2019 PROPOSED IMPROVEMENTS

EXHIBIT B

IV. Fort Lauderdale Beach Parking Lot

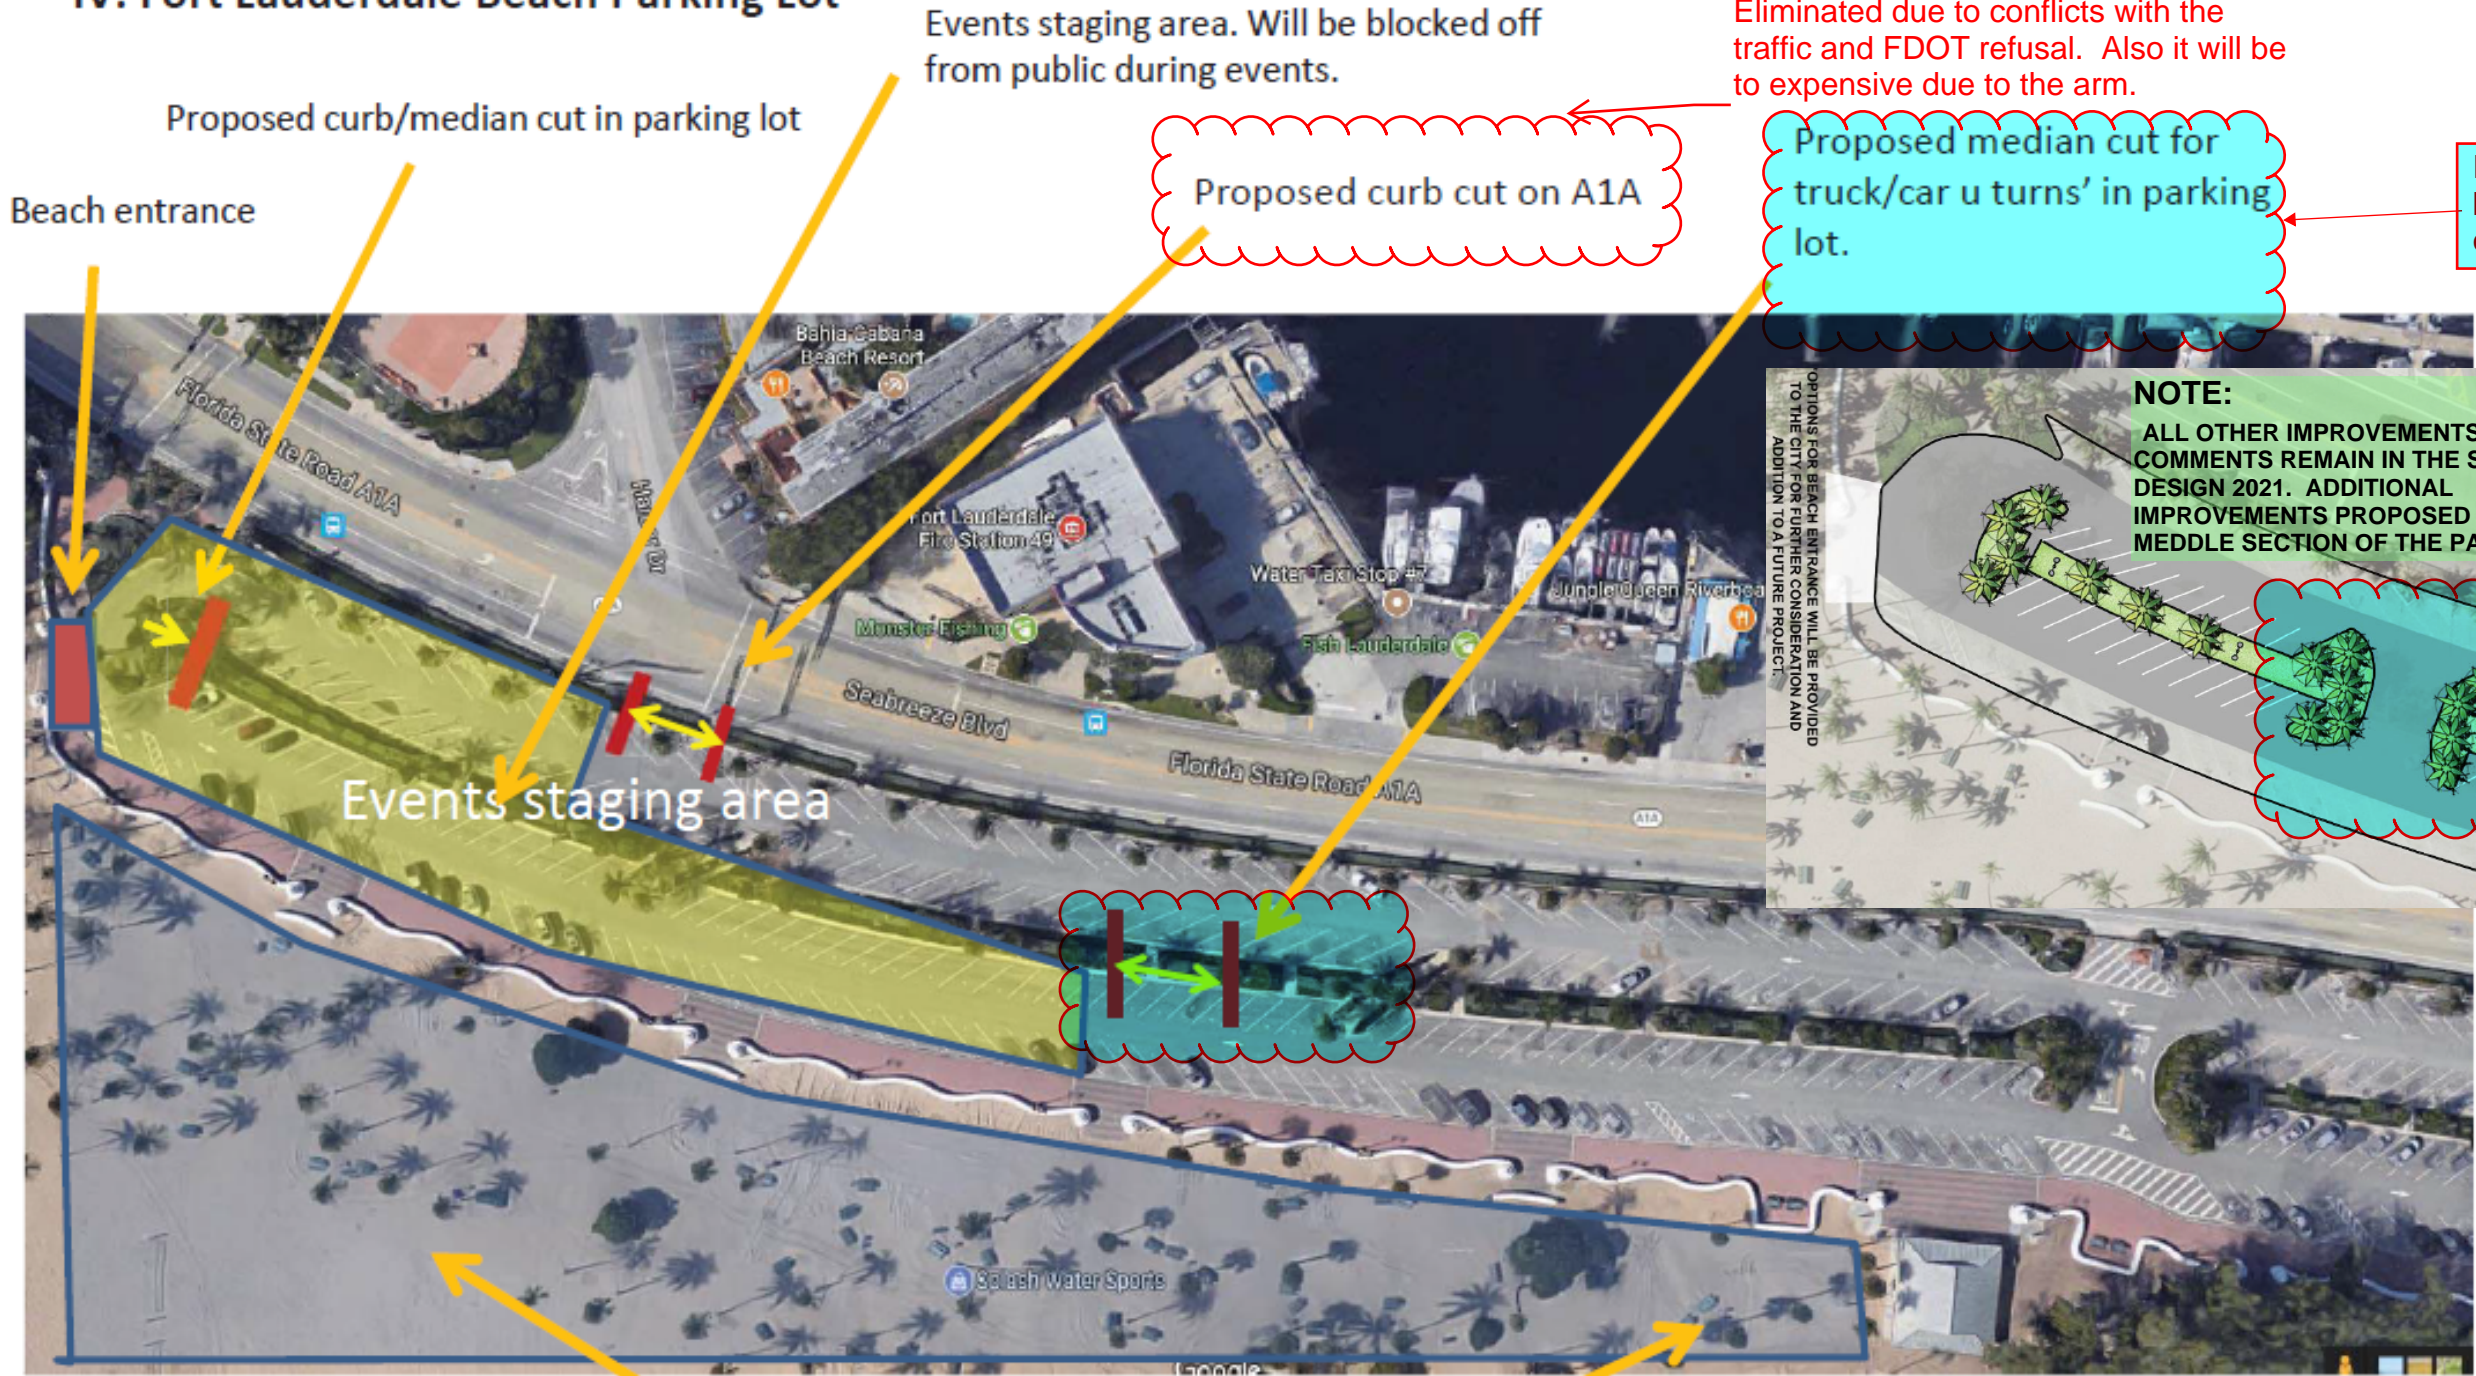
Eliminated due to conflicts with the traffic and FDOT refusal. Also it will be to expensive due to the arm.

Elimination requested by TAM's Director Dep. on March 2022

OPTIONS FOR BEACH ENTRANCE WILL BE PROVIDED TO THE CITY FOR FURTHER CONSIDERATION AND ADDITION TO A FUTURE PROJECT.

PROPOSED IMPROVEMENTS 2021 - SOUTH SIDE

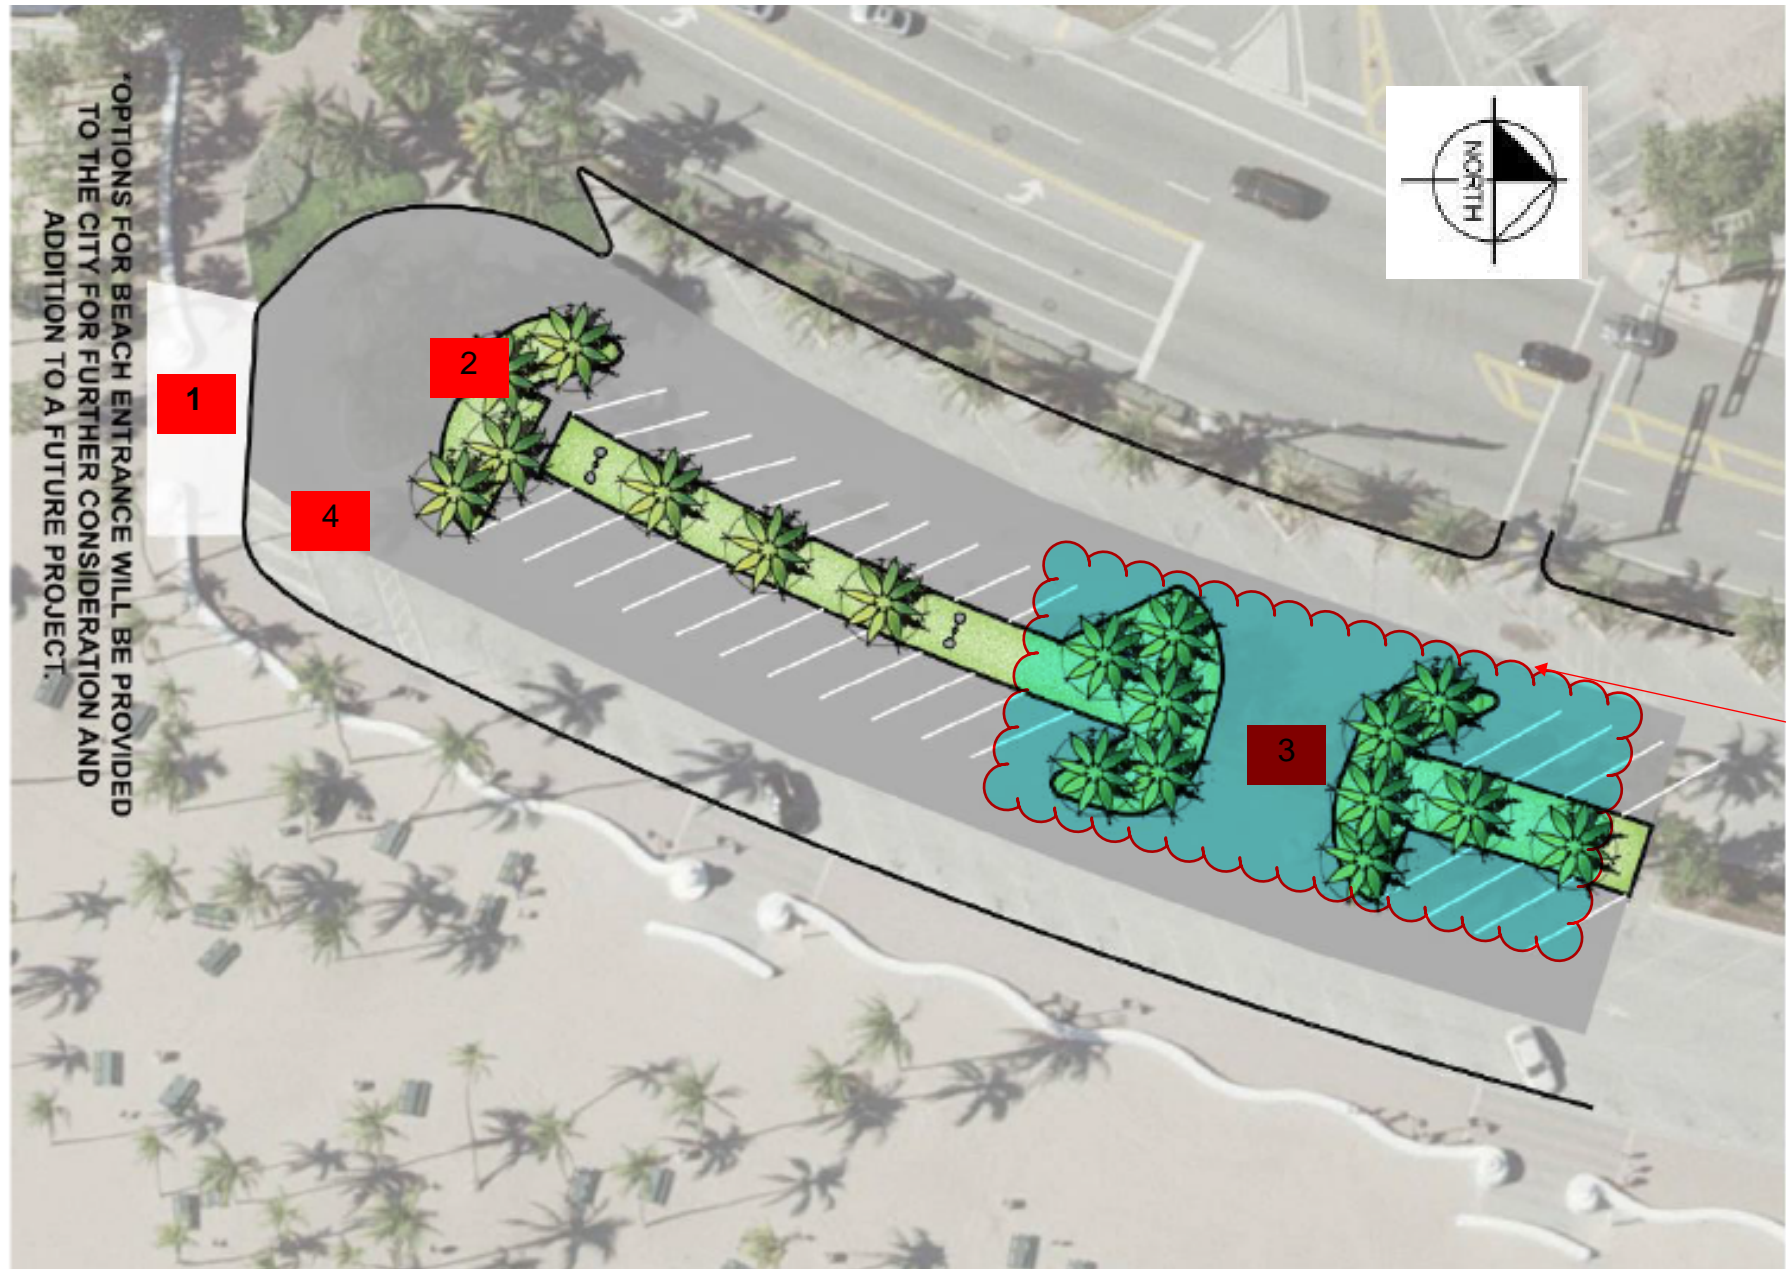
Eliminated as there is no single point of connection that will benefit all the events and the existing water and sewer connections can be used as needed. All the events have different configurations that will require different points of service. Electrical connection for the south side to be coordinated with FP&L during design.

- Proposed Improvements:
1. Beach entrance renderings will be provided in the task order for further analysis and consideration of the options.
 2. South planter to be reduce to make staging area bigger for the events.
 3. Proposed median cut to provide an additional location for the cars to turn.
 4. Conduits to be run to provide new point of connection.

Elimination requested by TAM's Director Dep. on March 2022

1. Existing entrance to be modified as needed for truck access. Entrance will be used just during special events.
2. Planters to be modified to allow a bigger staging area.
3. Proposed median cut to provide an additional location for the cars to turn.
4. Conduits to be run to provide new point of connection.
